(The Items in This Bulletin Supersede Items "C" and "D" in Service Bulletin No. 73-1, Dated 9/2/72.)

- A. MCM 120-140-165 Shift Cable Damage Prevention
- B. MCM 215E and 215H Bell Housing to Drive Shaft Housing Gasket Installation

Figure 1. Flywheel Clamp Location

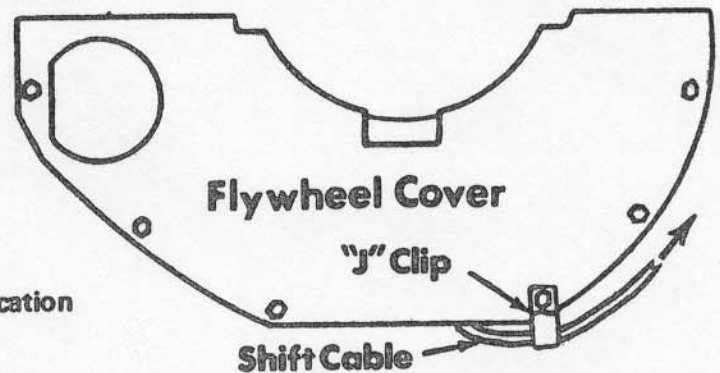
Under certain conditions during severe boat operation, the MCM 120-140-165 stern drive shift cable could become damaged between the gimbal housing exhaust elbow and the engine flywheel housing, making it inoperative. As a precaution, keep the shift cable away from this area. Install a "J" clip (C-54-61001) on the engine flywheel housing cover, place the shift cable in the "J" clip and bend the clip closed. (Figure 1) Remove screw from the bottom left side of the flywheel cover and replace it with screw C-10-26065, fastening the "J" clip (C-54-61001) in a vertical position. The stern drive unit shift cable MUST BE routed in the clip horizontally.

*NOTE: Use of the "J" clip (C-54-61001) will not require removal of shift cable from transom assembly, as required with clamp C-54-52925.*
